Torrens Road Catchment

Draft Stormwater Management Plan

**City of Charles Sturt
City of Port Adelaide Enfield**

March 2015

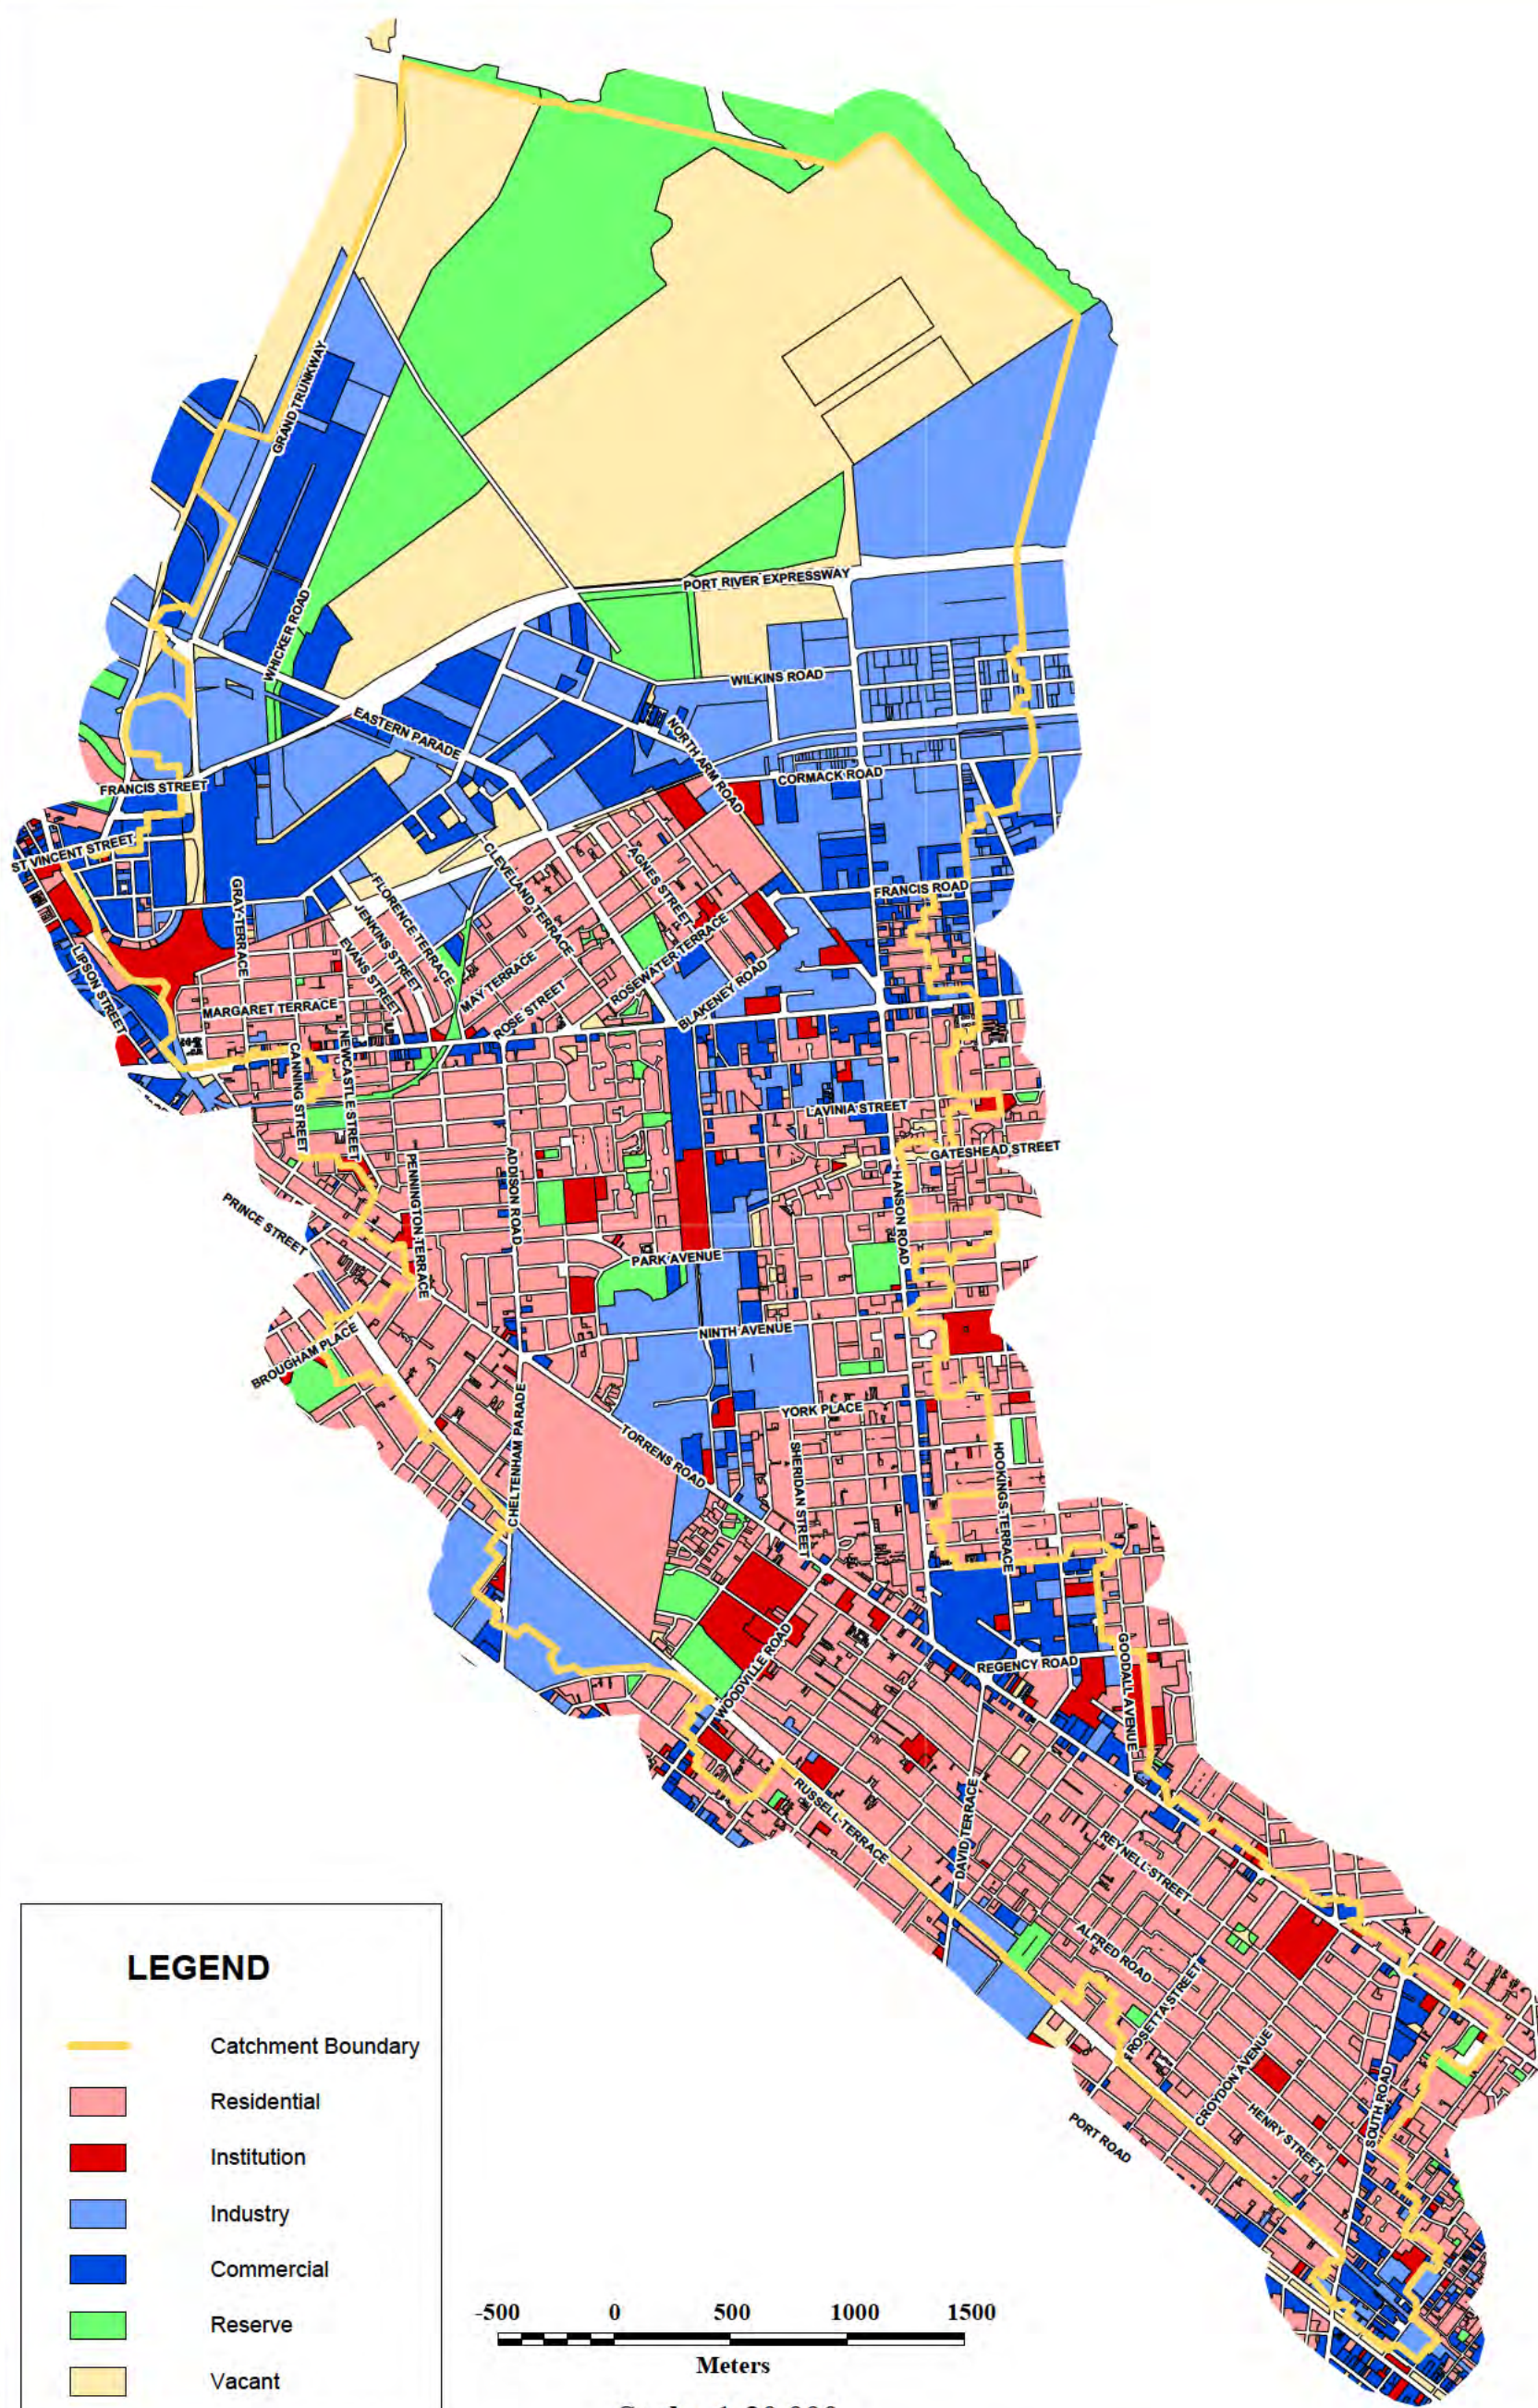
- Reference is made to Renewal SA's land holdings being "known as the TRDA Ponding Basin". It is requested that the land is referred to as 'existing key industry land' as per the *30-year Plan for Greater Adelaide*.
- Figure 2.2: The former Dean Rifle Range is shown as "Reserve". Consistent with the above, this should be shown as a combination of Reserve/Vacant land. There are consequential amendments to Table 2.1.

Figure 4.2

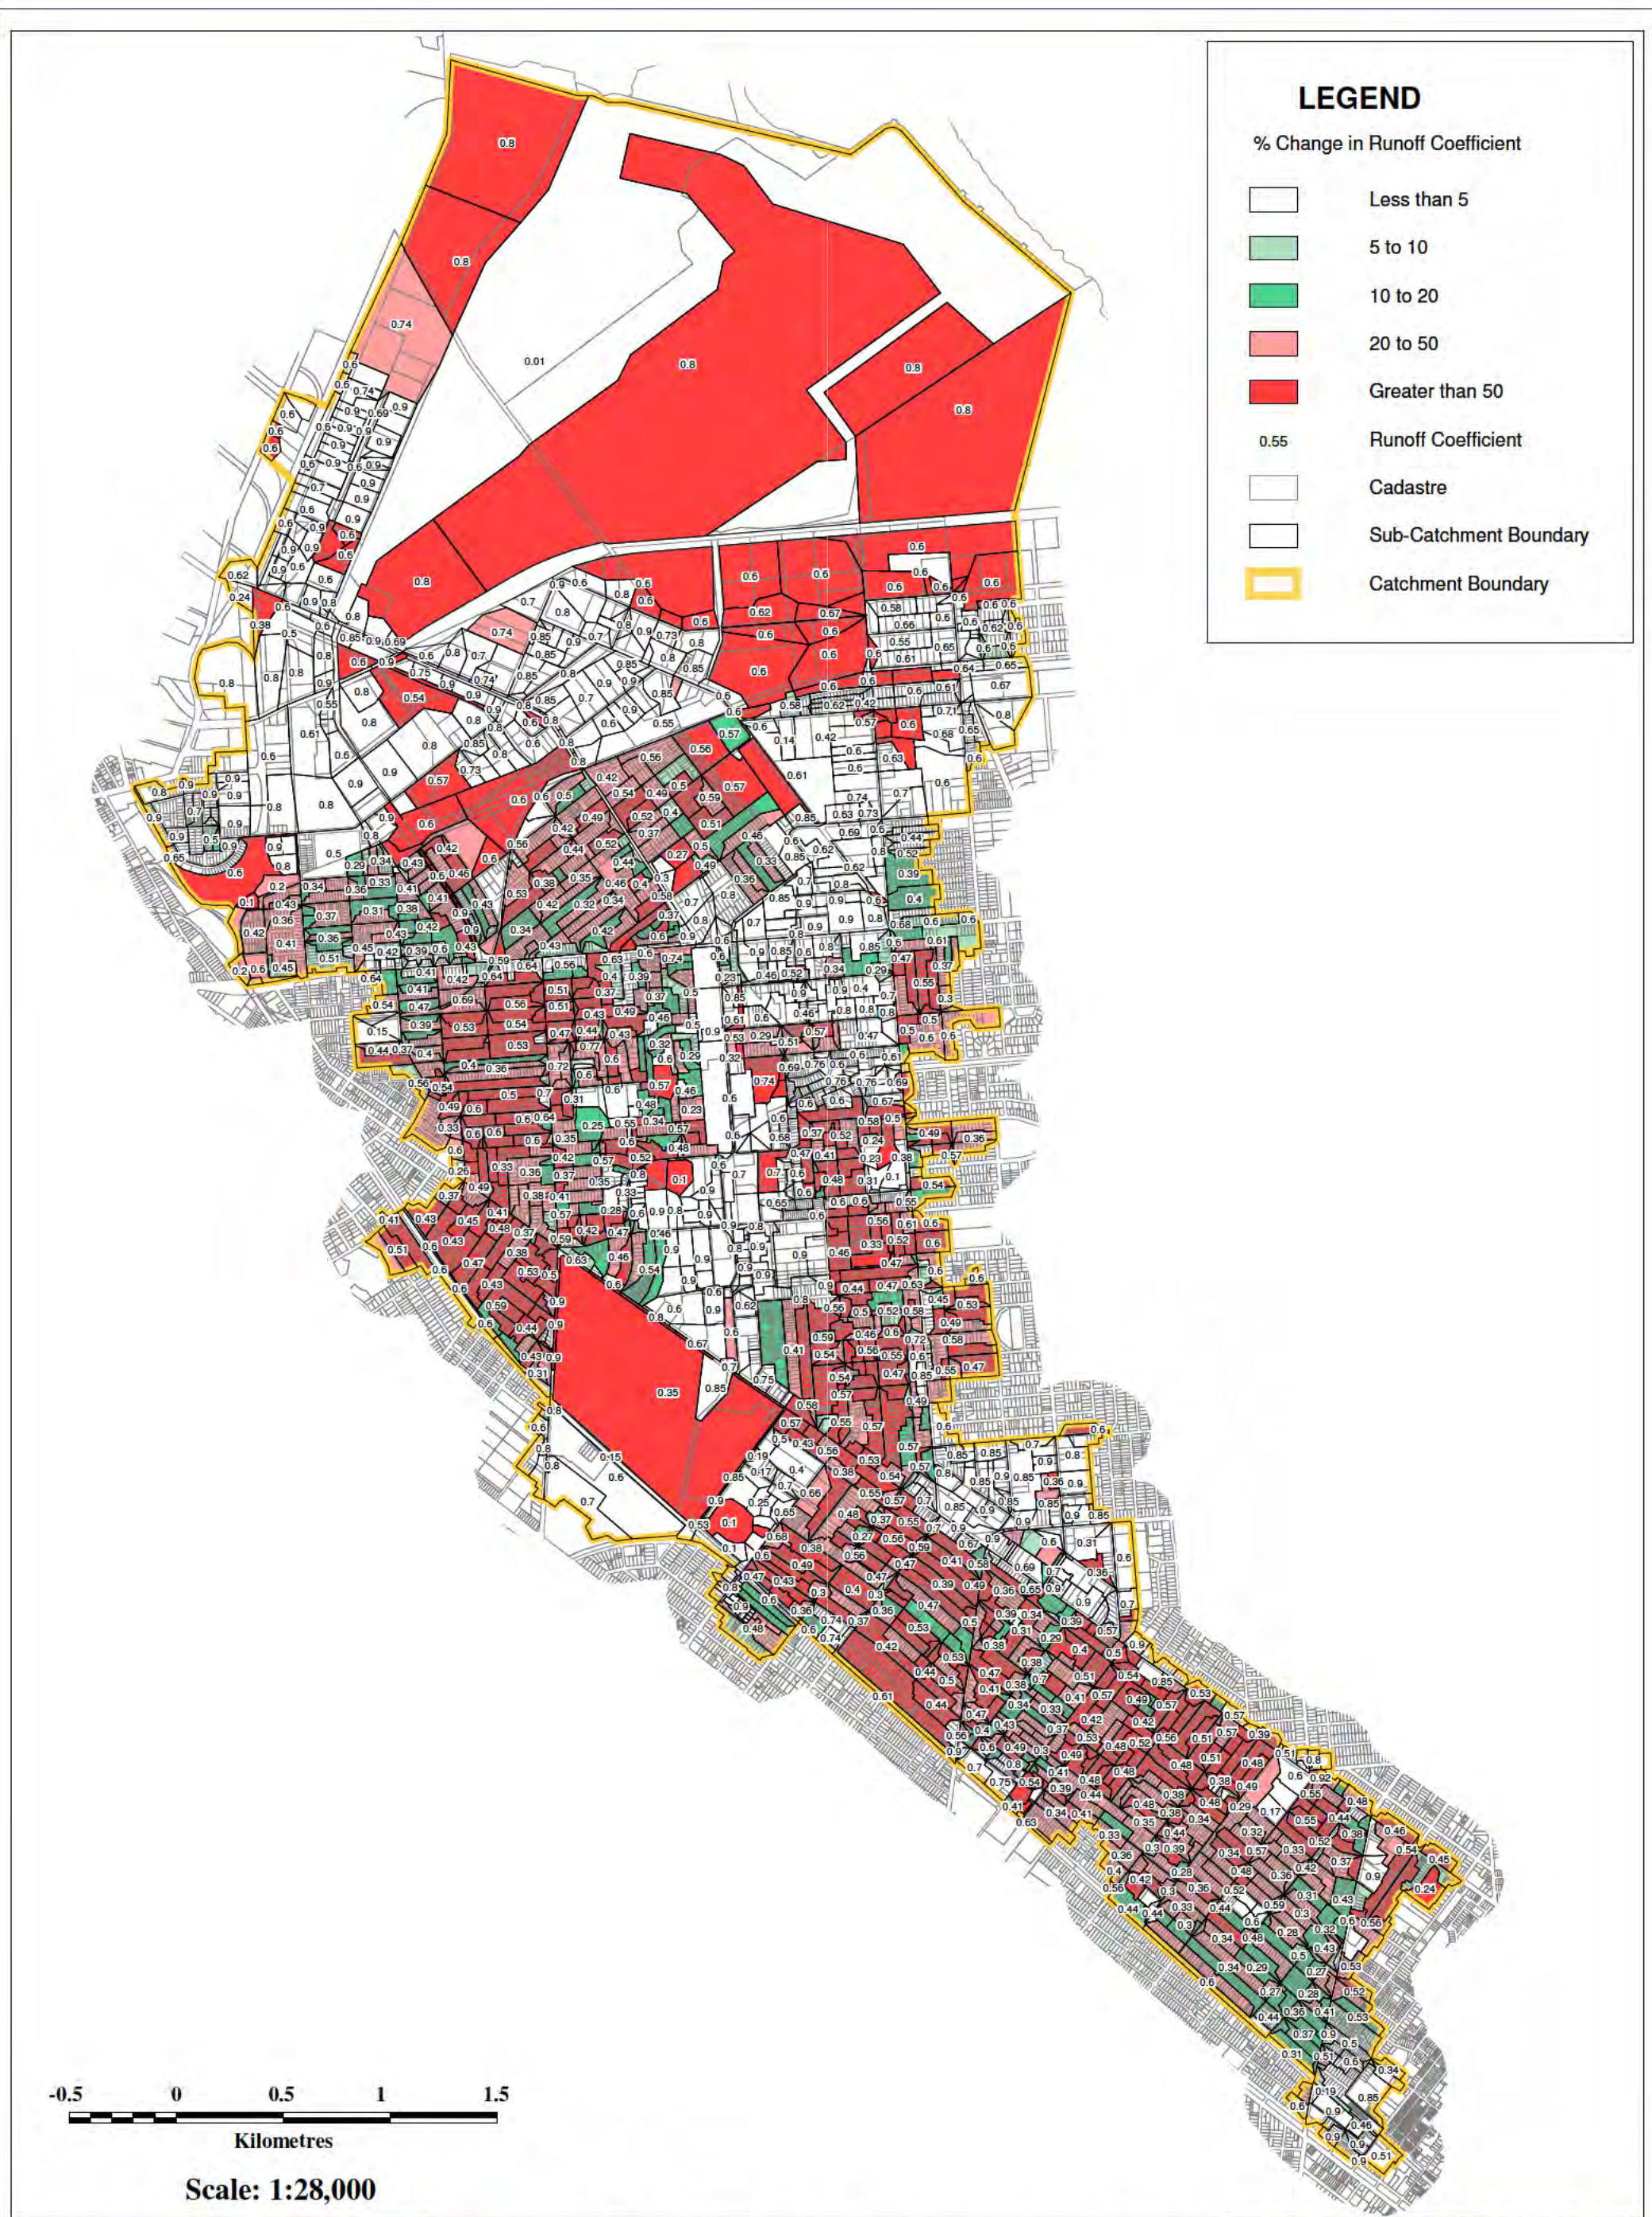
- The introduction is silent on discussions held with Renewal SA in the context of Gillman (despite section 4.4).
- Figure 4.2 assumes that the existing runoff coefficient (over the area included in Figure 2.2 as "Reserve") is unchanged (i.e. no development is modelled). Renewal SA's expectation is that this is likely to under-estimate the level of development in the 10-year horizon.

Organisation	Response	Comment / Action
		does not have a negative effect. The timing of preparation and issue of drafts of this Plan also overlaps some of the investigations at Gillman. The wording has been reviewed where appropriate to more closely reflect the current status of this land, while still ensuring that reference to appropriate investigations is maintained.
	Land use descriptions in Section 2 need to be adjusted to reflect the current status of land in the Gillman area and Figure 2.2 needs to be adjusted to properly reflect land use.	Wording in Sections 2.2 and 2.3 have been adjusted and the associated Figures and Tables modified.
	Reference to the Structure and Master Plans for the Gillman area should be included.	The work undertaken by Jensen Planning and design in 2009 and 2013 associated with planning in the Gillman area has been added to Section 3.
	Description of development potential of SAHT land and Gillman needs to be modified to reflect current status.	Wording of Section 4 adjusted in relation to SAHT land and Figure 4.2 changed to show development at Gillman within 10 years,
